1. Is the lead thickness for the standard used to determine the reject rate the minimum lead thicknesses, in the table below, which I took from the drawings associated with the respective shielded containers?

Figure 7-23 from Regulatory Hypothetical Accident Condition Type B Testing for the HalfPACT Shielded Container Payloads

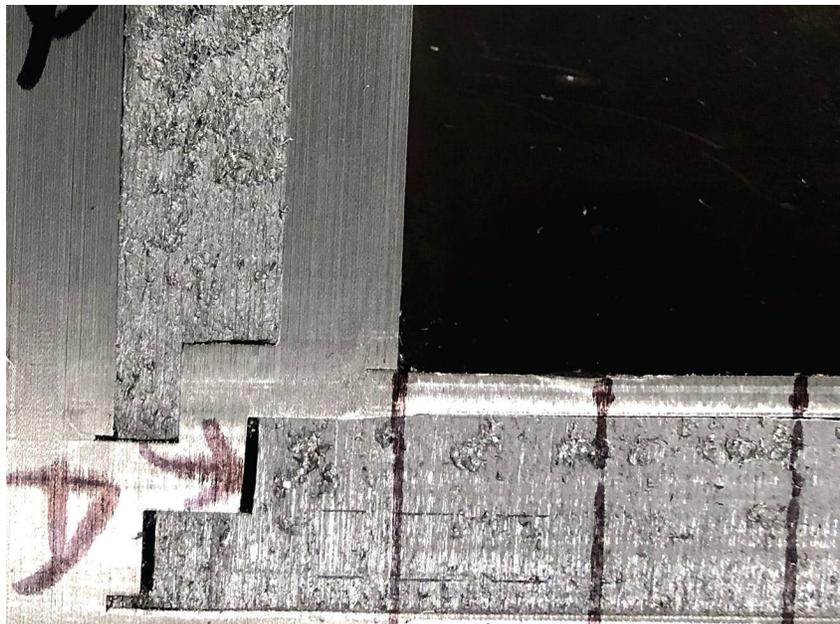
2. Is the standard used to determine the reject rate not a stepped configured (i.e., the configuration seen in the figure below adjacent to the “arrow” and the “D”), but a simple lead plate sandwiched between two stainless steel plate (i.e., the configuration seen in the figure below farthest from the “arrow” and the “D”)?

The calibration standard that is used to determine the reject rate is comprised of two flat steel plates representing the inner and outer shells at their minimum thicknesses and a flat lead plate at a thickness that's given in the above table from Question 1. The width and length of the calibration standard is of sufficient size to preclude indirect gamma radiation from affecting the measured reject rate.

Gamma scanning is performed from an elevation starting at the bottom of the shielded container's payload cavity to the top of the payload cavity. Slant shots below and above these axial limits are not performed due to the difficulty of getting accurate and meaningful answers from a calibration standard that is not configured for those specific geometries.
